FINAL ORDER

The Special Standards Request Form you submitted for owner: City of Brookings, Start Card number 1046865, is hereby approved for the following: You may construct this community well as described on your Special Standards Request Form dated August 5, 2020. All other well construction standards must be met. A copy of your Special Standards Request Form is enclosed.

Special Standards Request Form

(2) Start Card Number(s)(for work to be done): 1046865 / ID# 136502

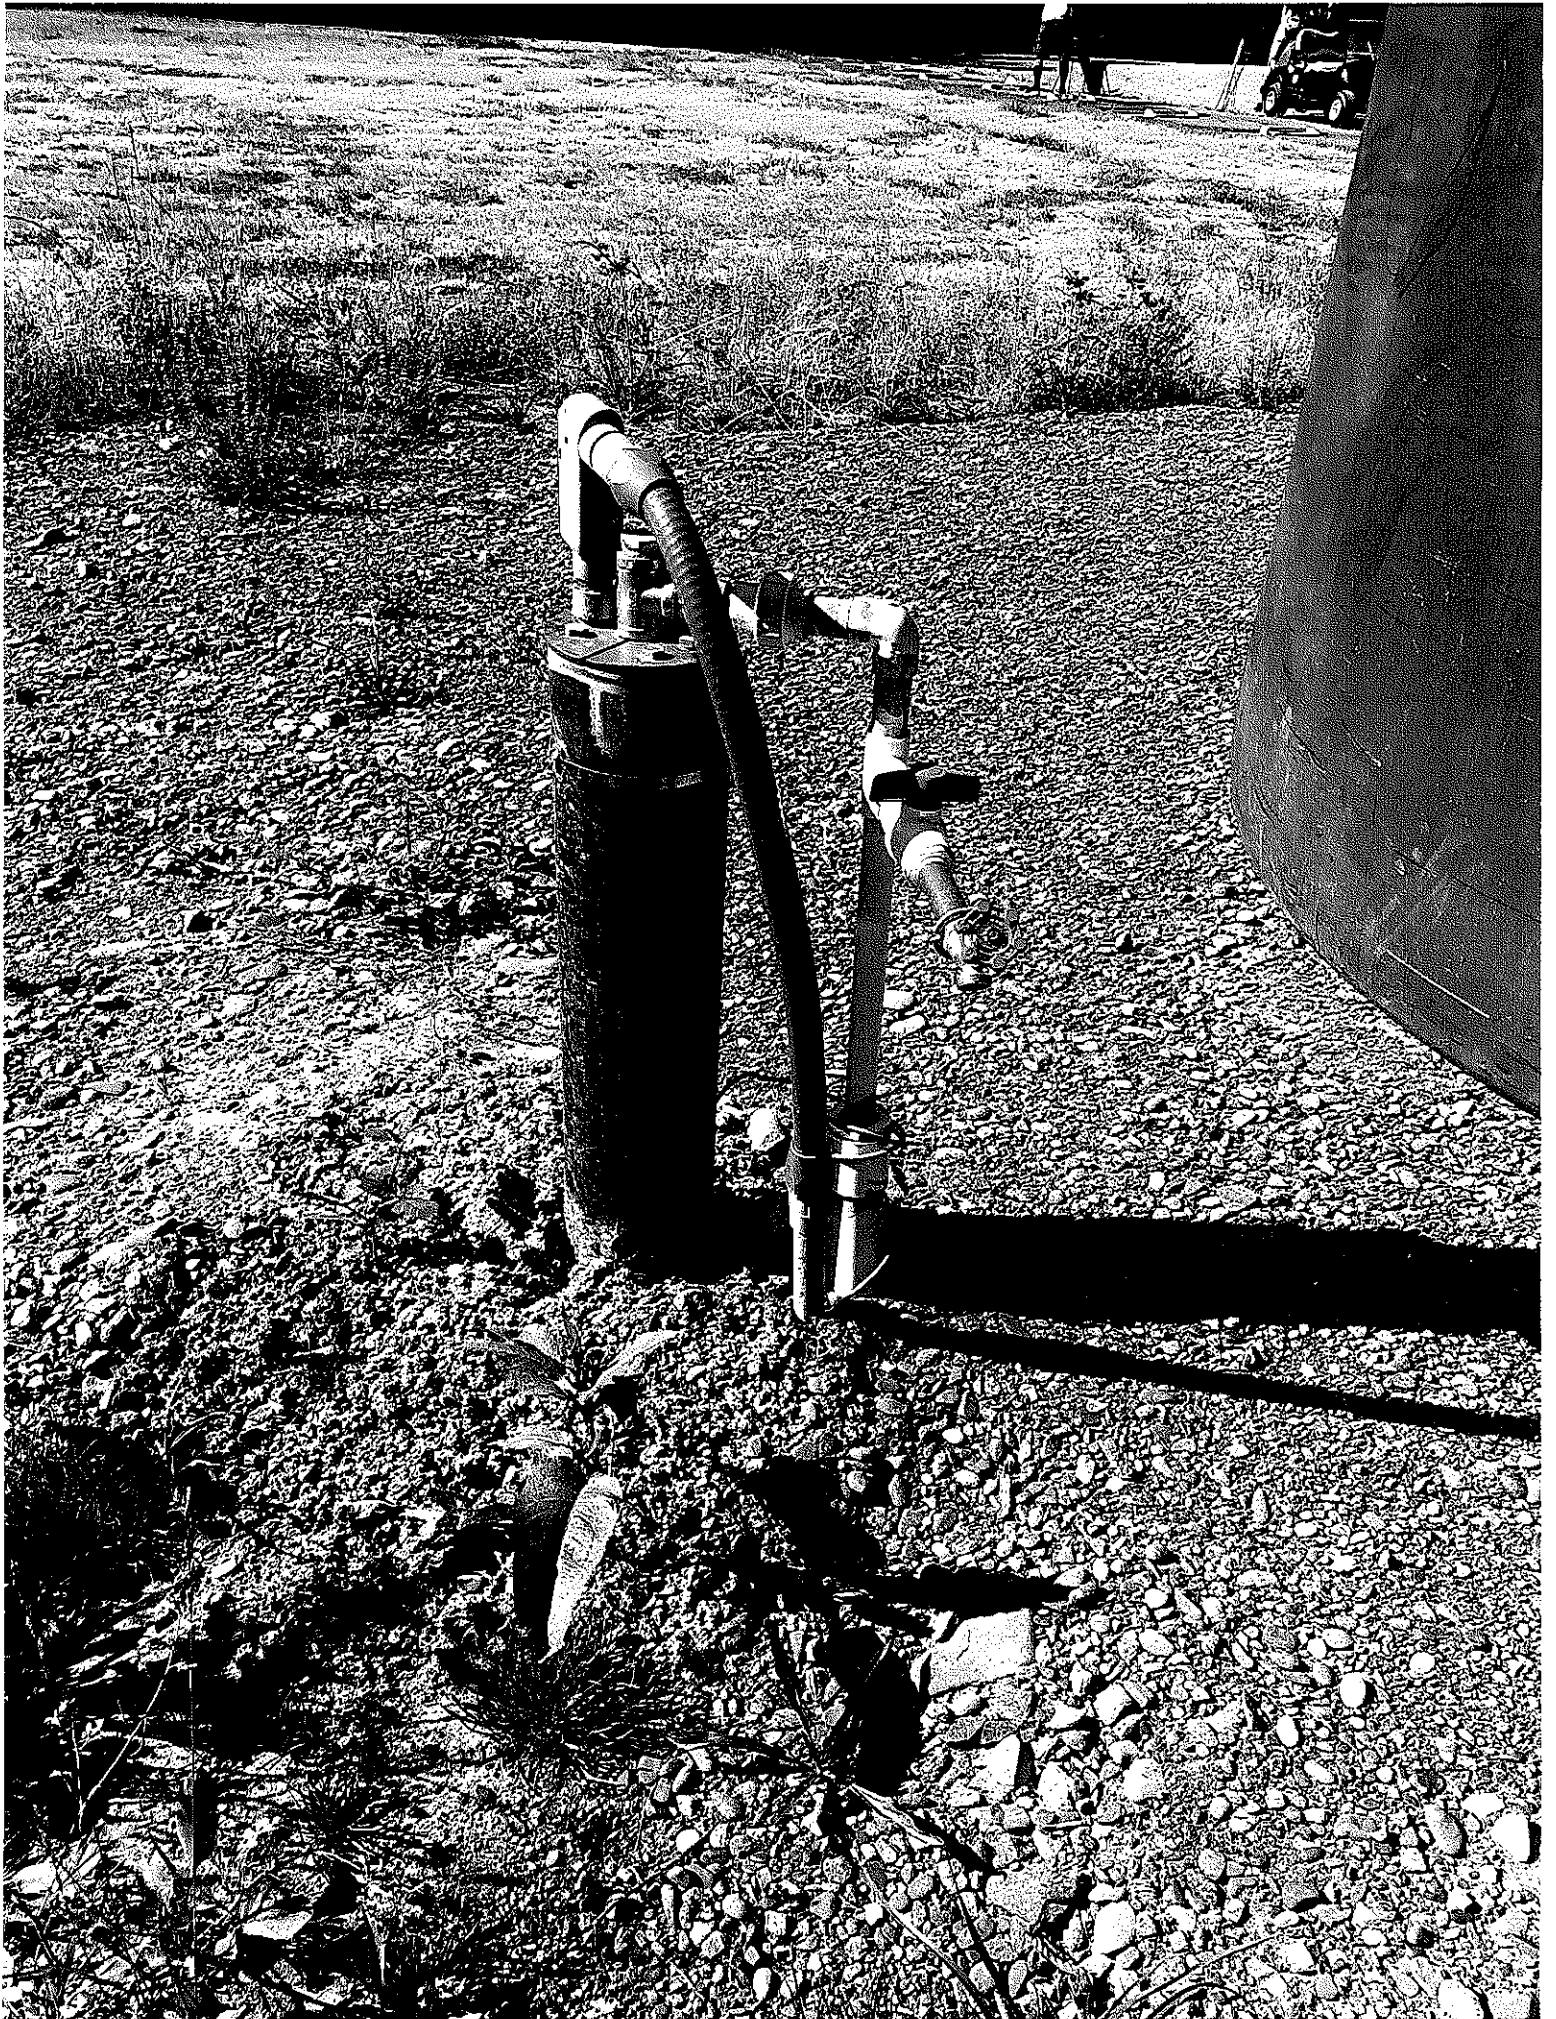
For over a decade, we have been drilling 5 inch PVC sand and gravel wells with an artificial filter pack around the screen. We drill a 10 inch hole with a bentonite slurry to the bottom of the sand and gravel on top of the bedrock. After the well is developed, we usually install the bentonite seal from the top of the sand pack to 2 feet below ground level. We set the 6 inch steel casing on top of the bentonite seal and push it into the bentonite seal to 1.5 feet above the 5 inch PVC casing. The 6 inch steel casing has a 6 inch by 12 inch door cut in the steel casing 2 to 3 feet below ground level to accommodate a pitless adapter to access the PVC casing if necessary.

The remainder of the 10 inch bore is filled with bentonite to ground level. Filling the cut out in the steel casing and filling the void between the 5 inch PVC and the 6 inches of steel. The 6 inch steel casing has a 2 inch annular space around the casing. In order to accommodate an 8 inch steel casing, we would have to drill a 12 inch hole. The cost to the customer would probably double (i.e. 8 inch steel casing, well seal or cap, retooling to drill a 12 inch hole to accommodate the 8 inch steel casing for just 4 feet).

Please keep in mind that each time you construct a well in this manner, a special standard request must be submitted for consideration. The Department does not issue blanket special standards for a drilling process. Please also keep in mind that the rules do not specify that a two-inch annular space is required for protective steel casing in PVC well completions. The rules only require that the steel casing be sealed at least four feet into the ground within the annular seal. There are more requirements as well, but I wanted to address your comments regarding a twelve-inch borehole.
